Office Action Summary

10/575,318

BRUCKER ET AL.

DETAILED ACTION

Fig. B

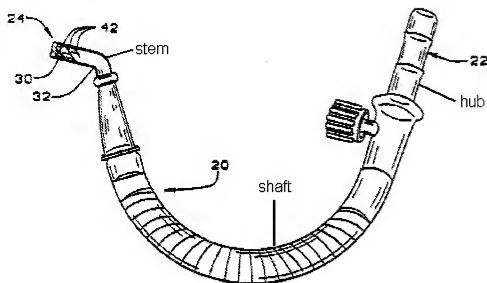
61. Re claim 60, Lindsay discloses a shaft (best seen in Fig B above) affixed to a proximal end of the stem and a hub 28 (Col 2, Line 37) but does not disclose a strain relief element affixed to the proximal end of the shaft and to the distal end of the hub. Klima et al., however, teaches a strain relief element 22 (Fig 1) interconnected between a hub 16 (Fig 1) and a proximal end of a shaft 20 (Fig 1) for the purpose of providing a connection between the hub and the shaft (Col 2, Line 47). Therefore, it would have been obvious to one of ordinary skill in the art at the time of the invention to modify Lindsay/Stevens et al./Savage et al. to include a strain relief element, as taught by Klima et al., for the purpose of connecting the hub and shaft (Col 2, Line 47).

Fig. C

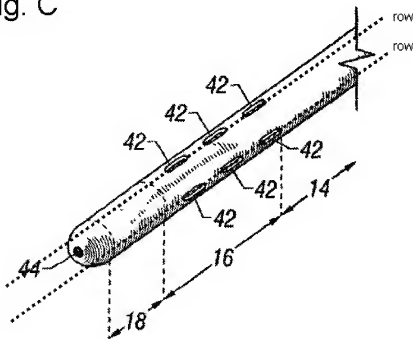
having a plurality of pairs of longitudinally arranged rows (best seen in Fig C above) with each of said row pairs being laterally spaced generally equidistantly from its neighbors (as seen in Fig C above; Page 12, Lines 3-4) for the purpose of ensuring a substantial cancellation of the fluid force vectors (Page 11, Lines 5-7). Therefore, it would have been obvious to one of ordinary skill in the art at the time of the invention to modify Lindsay/Stevens et al. to include microholes arranged into a plurality of pairs of longitudinally arranged rows spaced equidistantly from each other, as taught by Savage et al., for the purpose of ensuring a substantial cancellation of the fluid force vectors (Page 11, Lines 5-7).

Fig. D

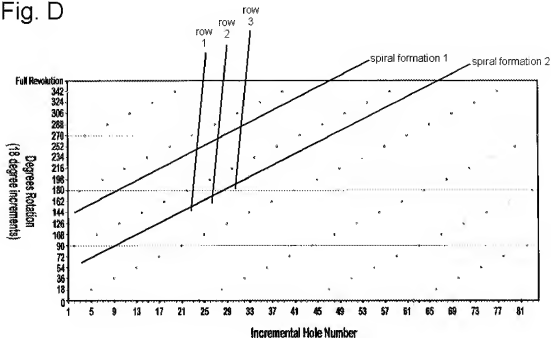
65. Re claim 75, Lindsay/Stevens et al./Savage et al. disclose all the claimed features except that the porous section has two of said spiral formations each of which having a plurality of laterally-offset rows of microholes, with each of said rows in one of said spiral formations being diametrically opposite from a counterpart one of said rows in the other of said spiral formations. Mottola et al., however, teaches that the porous section (formed by microholes 34, Fig 3) has two of said spiral formations (best seen in Fig D below; Col 3, Line 39) each of which having a plurality of laterally-offset rows of microholes (best seen in Fig D below) for the purpose of creating a complete dispersion of fluid (Col 3, Line 40). Mottola et al. does not explicitly teach that each of said rows in one of said spiral formations being diametrically opposite from a counterpart one of said rows in the other of said spiral formation but does teaches that the angles of spacing and inclination between holes can be modified (Col 4, Lines 42-64); a change in such angles could produce rows that are diametrically opposite from a counterpart row in the second spiral formation for the purpose of creating a complete dispersion of fluid (Col 3, Line 40). Therefore, it would have been obvious to one of ordinary skill in the art at the time of the invention to modify Lindsay/Stevens et al./Savage et al. to include two spiral formations having a plurality of laterally-offset row of microholes, as taught by Mottola et

al., for the purpose of creating a complete dispersion of fluid (Col 3, Line 40).

Fig. E

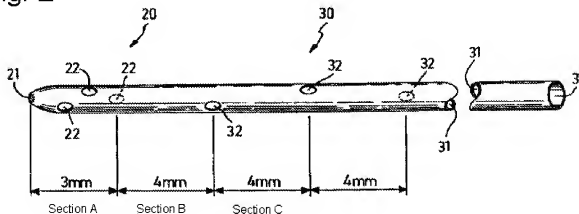
69. Re claim 34, Lindsay/Stevens et al./Savage et al./Mottola et al. disclose all the claimed features except that the microholes along the longitudinal axis are deployed in a plurality of sections of substantially equal length wherein the number of said microholes in each of said sections changes according to a linear progression. Eldor, however, teaches that the number of microholes 22, 32 (Fig 1) along the longitudinal axis are deployed in a plurality of sections A, B (best seen in Fig E below) of substantially equal length (as seen in Fig E below) wherein the number of said microholes in each of said sections changes according to a linear progression (1 microhole in section B, 3 microholes in section A as in Fig E below) for the purpose of injecting a desired stream of fluid (Col 4, Lines 49-50). Therefore, it would have been obvious to one of ordinary skill in the art at the time of the invention to modify Lindsay/Stevens et al./Savage et al./Mottola et al. to include microholes deployed in a plurality of sections having substantially equal length wherein the number of said microholes in each section changes according to a linear progression, as taught by

Eldor, for the purpose of injecting a desired stream of fluid (Col 4, Lines 49-50).
